**City of Globe**  
150 N. Pine Street  
Globe, AZ 85501

**ADDENDUM #1**  
**TO THE JUNE 25, 2025**  
**INVITATION TO BID**  
**FOR THE**  
**GLOBE SKATE PARK IMPROVEMENTS PROJECT**

**Addendum #1 Date: 07/14/2025**

## 07-14-2025 Proposed Skate Park General Layout

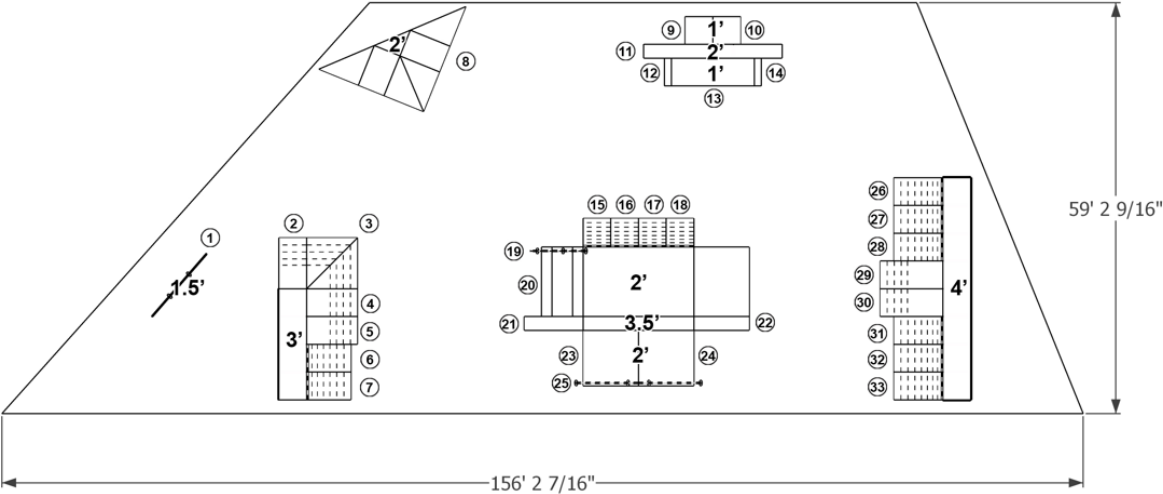
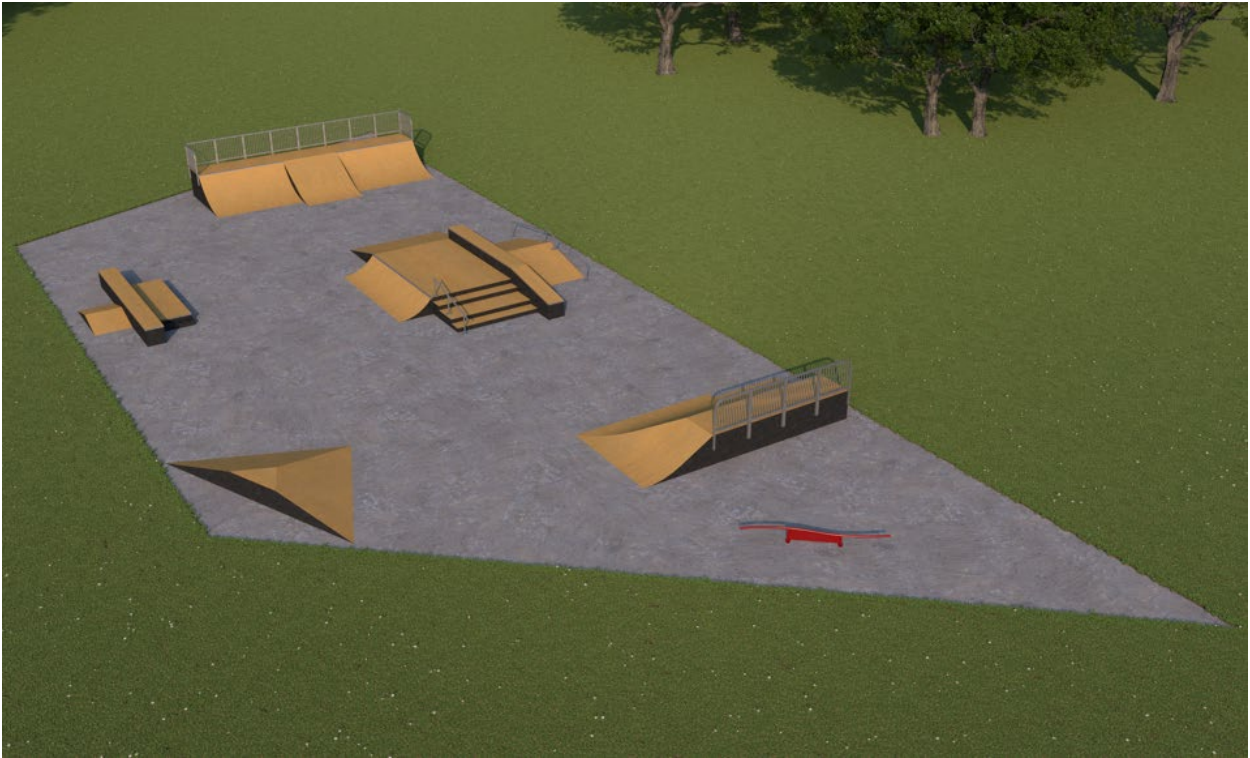
2. Question: Is there a design?

6. Question: What about the handrail location? If it's put where the drawing indicates, kids will use it as part of the skate park. Can it be moved?

Answer: The city has provided a general proposed layout, attached to this addendum, but other designs are up for consideration.

Answer: Bid per plan.
